## **SUNSET ACRES ON HIGHWAY 90 SUBDIVISION**

Engineering Comments: FINAL PLAT COMMENTS (should be addressed prior to submitting the FINAL PLAT for review and/or signature by the City Engineer):

# DETAIL SITE PLAN

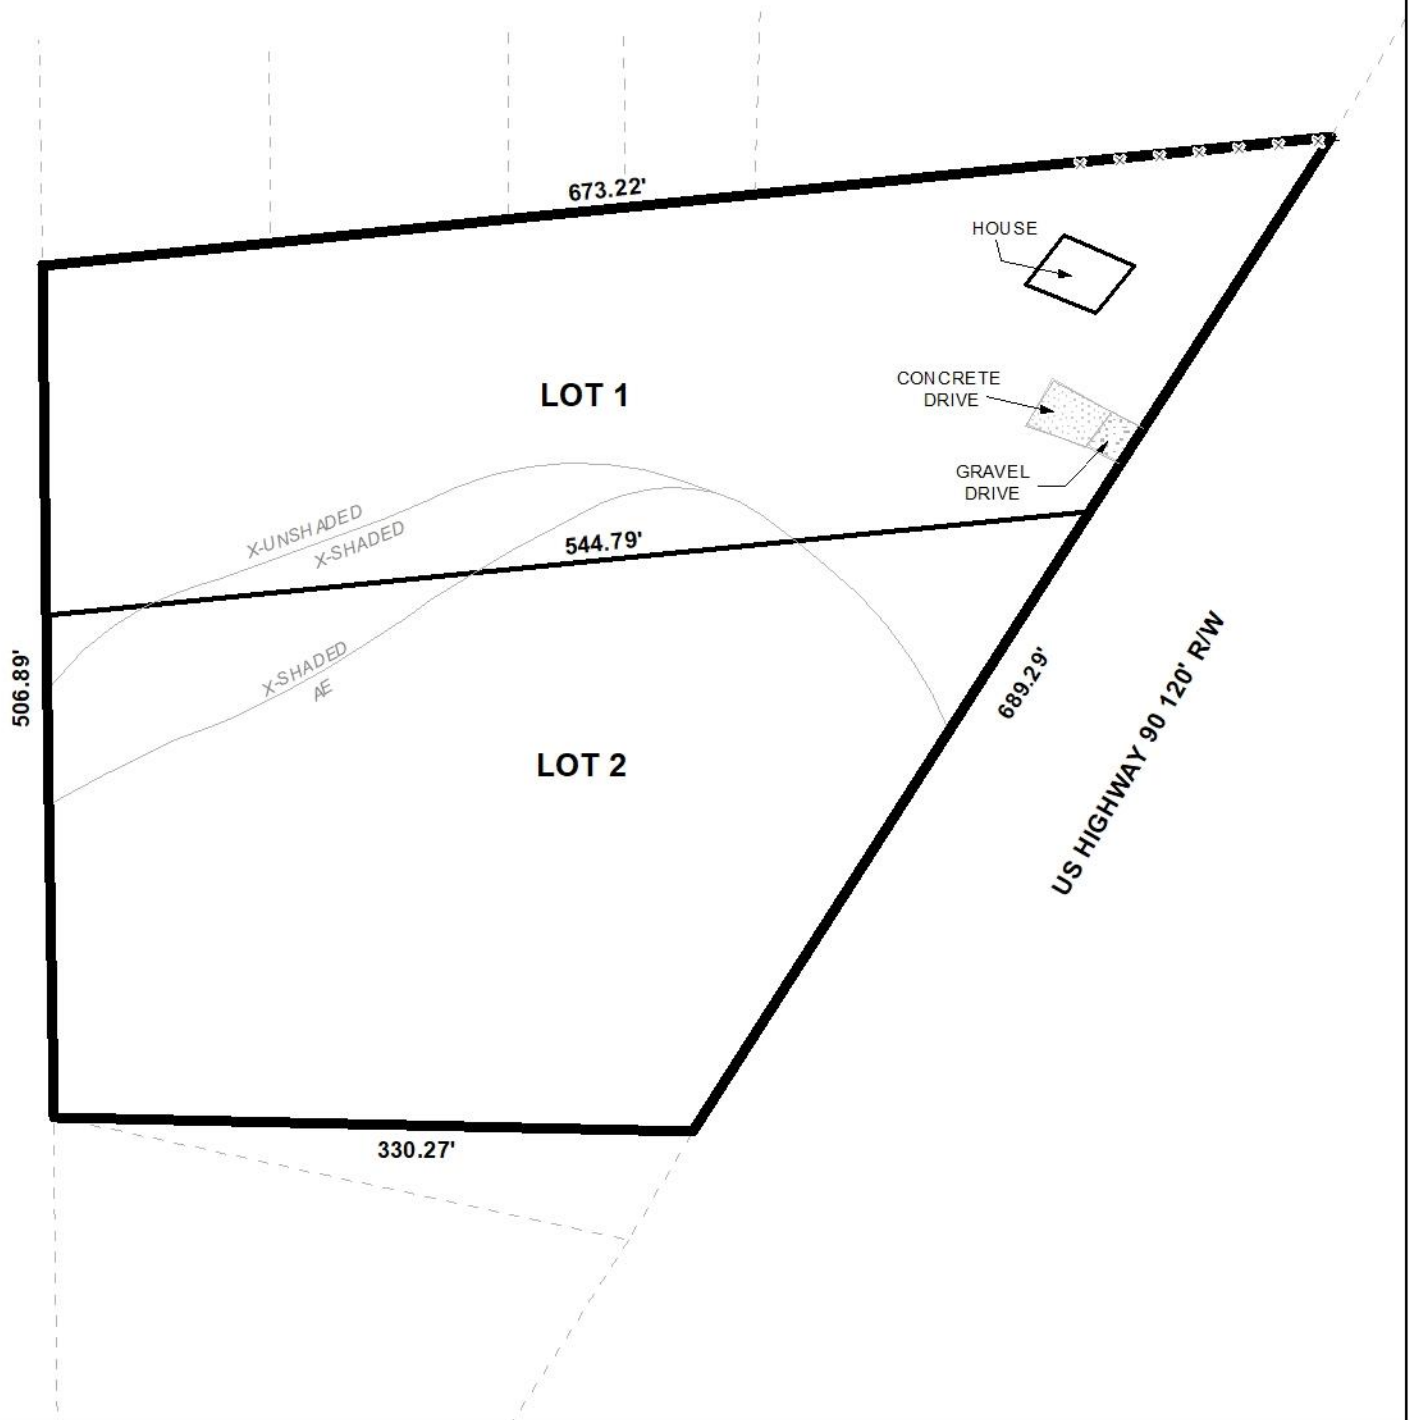
Both proposed lots have frontage along U.S. Highway 90 West, an ALDOT-maintained U.S. Highway and proposed major street with an existing right-of-way width of 120'. The preliminary plat illustrates adequate right-of-way width; therefore, if approved, no additional dedication should be required.

The proposed lots sizes are provided in square feet and acres on the preliminary plat. If approved, this information should be retained on the Final Plat.

The 25-foot minimum building setback is not illustrated on the preliminary plat per Section V.D.9. of the Subdivision Regulations. If approved, revision of the Final Plat to illustrate the 25-foot minimum building setback line along U.S. Highway 90 West should be required.

No easements are indicated on the preliminary plat. If any easements are recorded on the site they should be indicated and labeled on the Final Plat, and a note should be placed on the Final Plat stating that no structure may be placed or constructed within any easement without permission of the easement holder.

- 1) Revision of the Final Plat to depict the 25-foot minimum building setback line along U.S. Highway 90 West;
- 2) Retention of compliant right-of-way width on the Final Plat;

- 3) Retention of the lot size in both square feet and acres, or the furnishing of a table on the Final Plat providing the same information;
- 4) Placement of a note on the Final Plat stating that no structure may be constructed or placed within any easement without the permission of the easement holder, if applicable;
